BRIDGEWOOD SUBDIVISION
 SAN ANTONIO, BEXAR COUNTY
 PRELIMINARY OVERALL AREA DEVELOPMENT PLAN

POADP # 628

The City Staff Development Review Committee has reviewed Bridgewood Subdivision Preliminary Overall Area Development Plan # 628. Please find enclosed a signed copy for your files. Although your plan was accepted, please note the following:

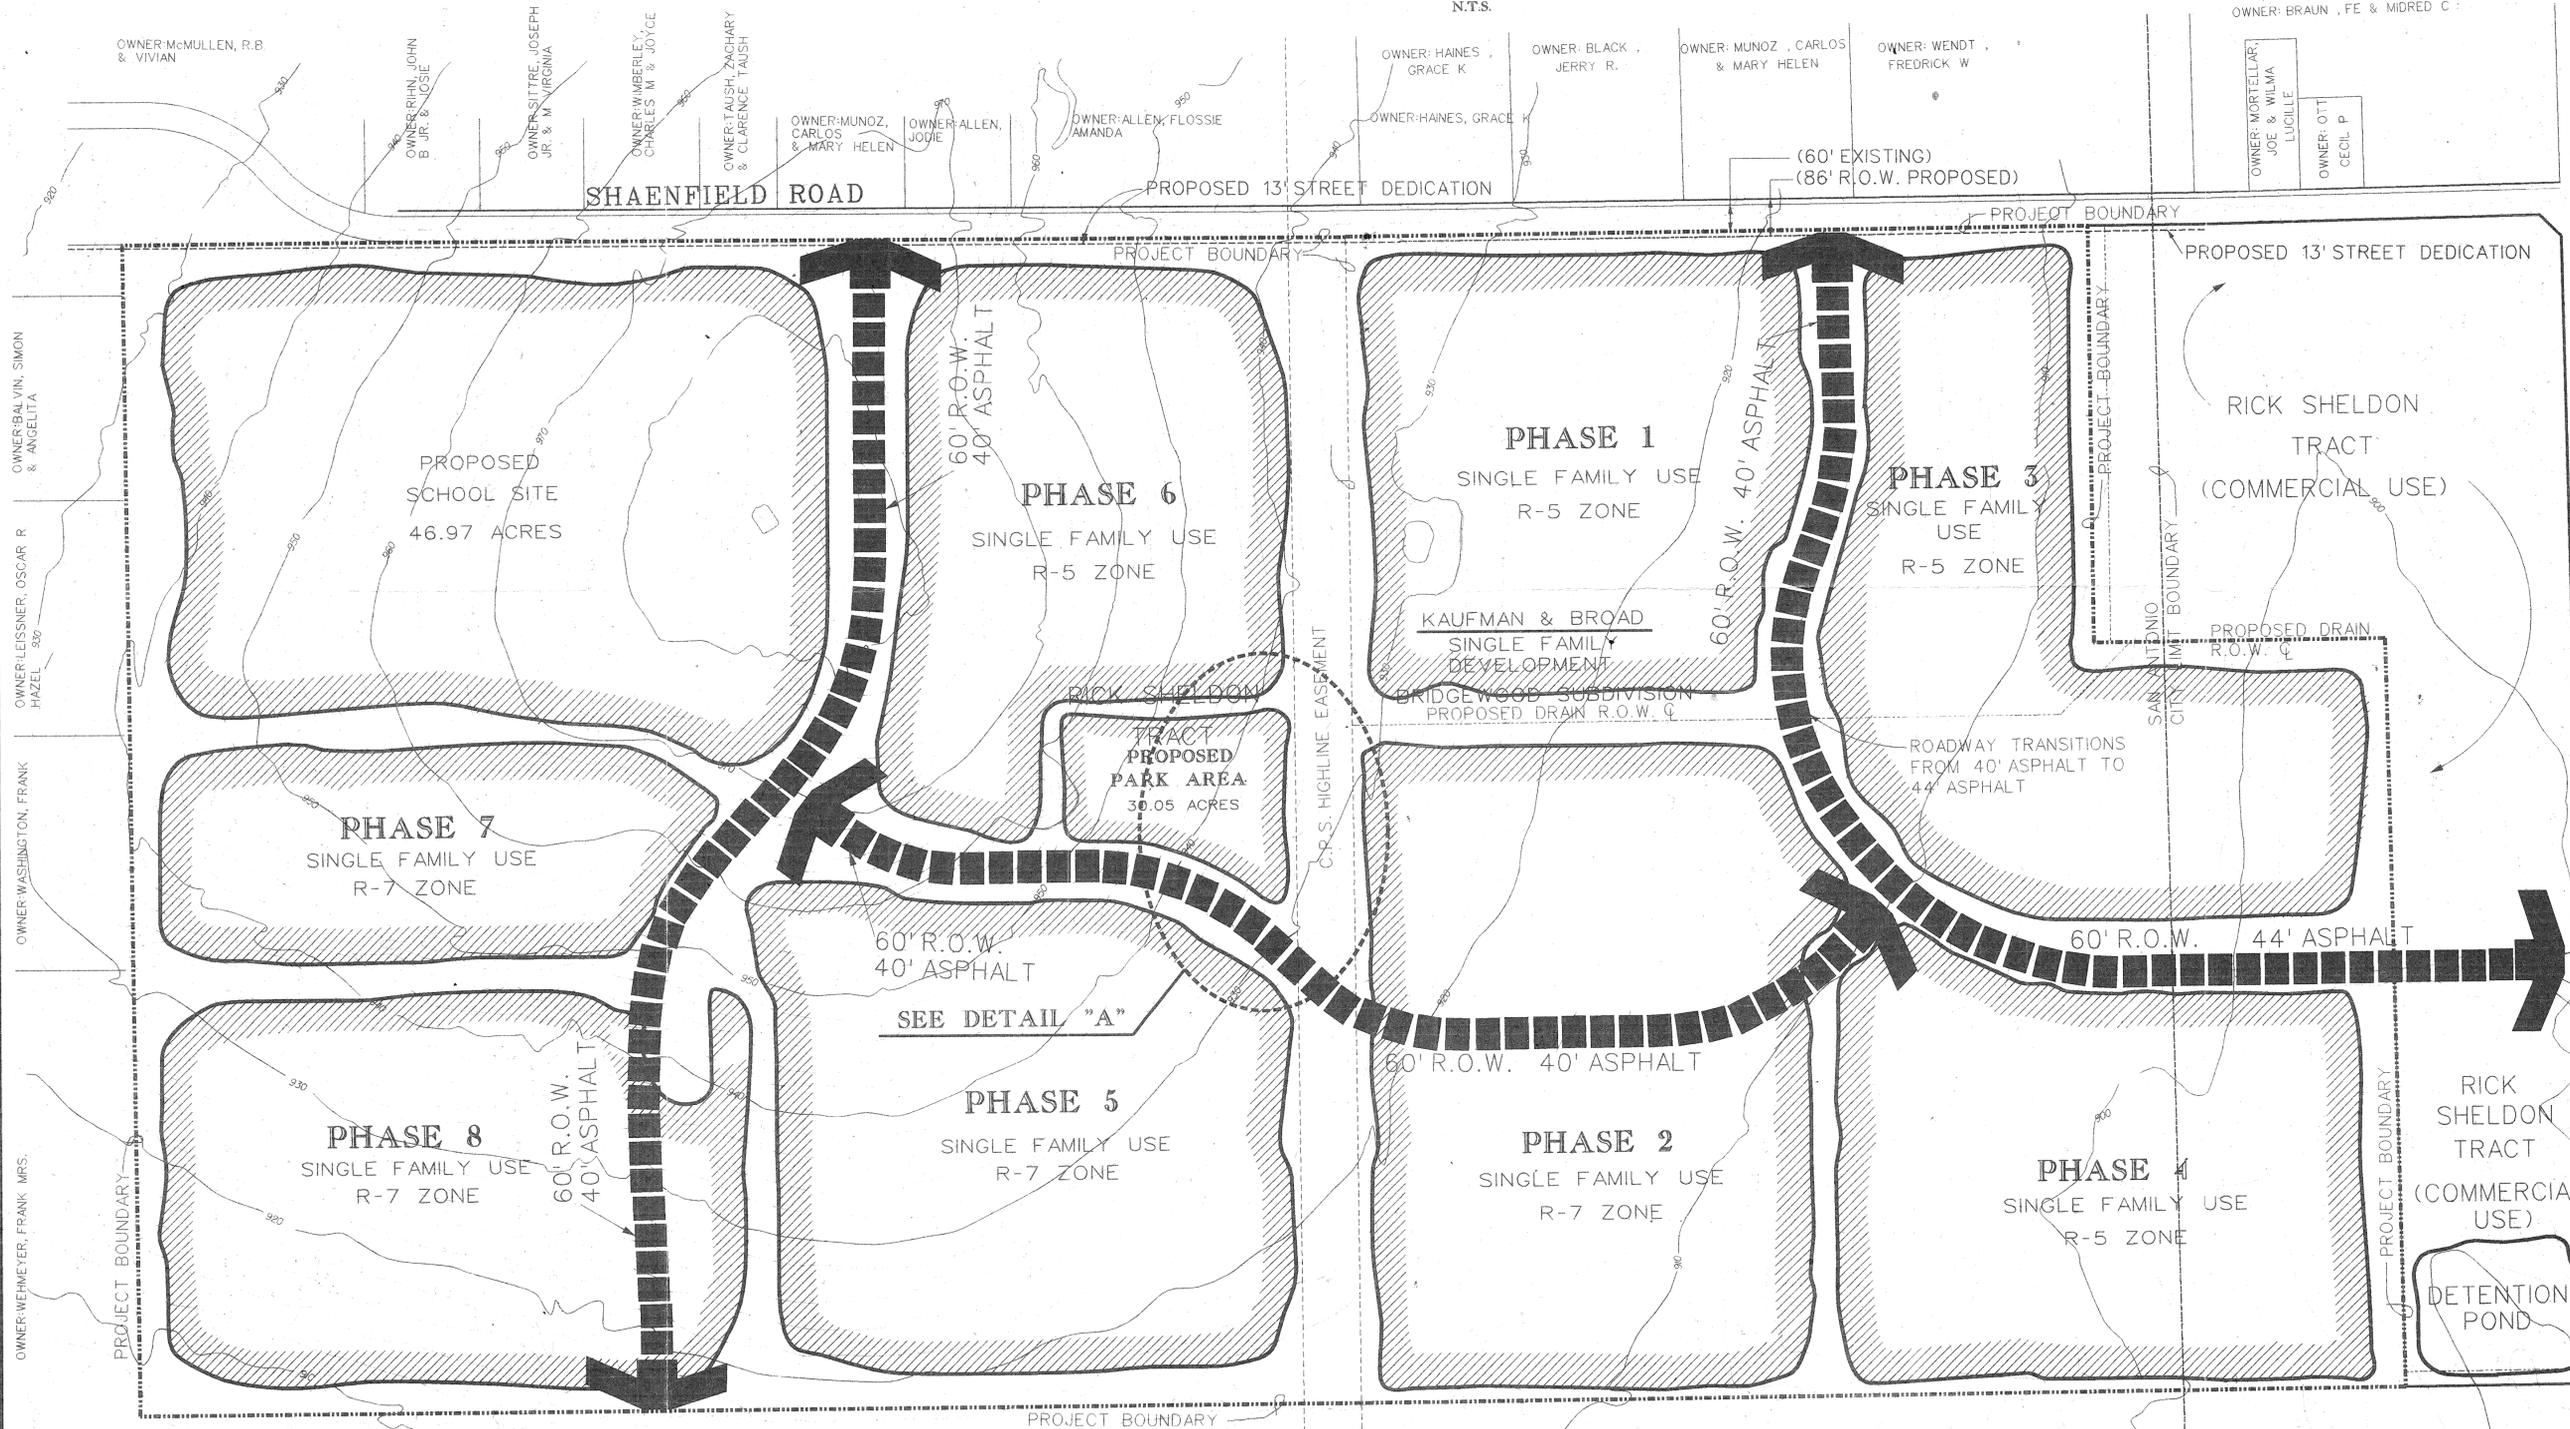
- Based on the topography, a Flood Plain Study and drainage review will probably be required during the platting process.
- A Level-3 TIA will be required to be submitted to the Department of Public Works prior to approval of the plat for phase two.
- This development will need to comply with tree preservation ordinance #85262. For information about these requirements you can contact Building Inspections at 207-7102.
- It will be expected that you will plat all of the property depicted in your POADP, to include: floodpains, drainage areas and open space.
- I would encourage you to work closely with the school district, so that they can plan accordingly.
